From: [Tim M](#)
To: [*CI-StPaul>Contact-Council](#); [#CI-StPaul_Ward7](#); [#CI-StPaul_Ward6](#)
Subject: St Paul Bike Plan Comments from Ward 7 Resident
Date: Tuesday, April 23, 2024 11:05:35 AM
Attachments: [image.png](#)

I am a resident of Dayton's Bluff and these are the comments I have on the St Paul Bike Plan. Overall it's a good plan, but there's a lot of missing pieces on the East Side.

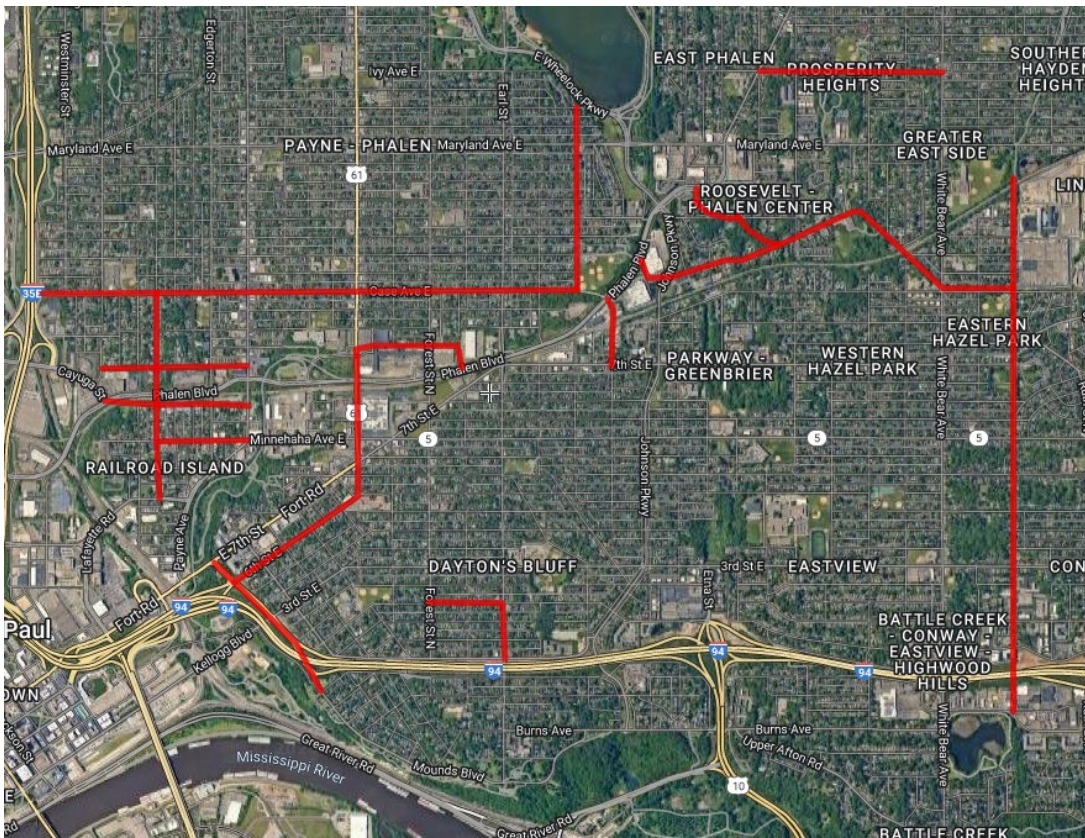
Railroad Island - There's a reason why this neighborhood has its name. By being fenced in on all sides by railroads, it requires bikers to go out of their way to go north or west of the neighborhood. The Cayuga Street station area plan had identified a reconnection of the former bridge over Phalen of Burr Street, and a connection from Bush Ave to Cayuga, not only creating a good connection for the future Purple Line but also to the Gateway Trail.

Other routes identified include: Case Ave, Whittall St, Wells St including an alleyway connection to Seeger Square Minnehaha Ave west of Edgerton, Duluth St north of Phalen and Atlantic south of Phalen

Here's an image of the routes that I've mentioned.
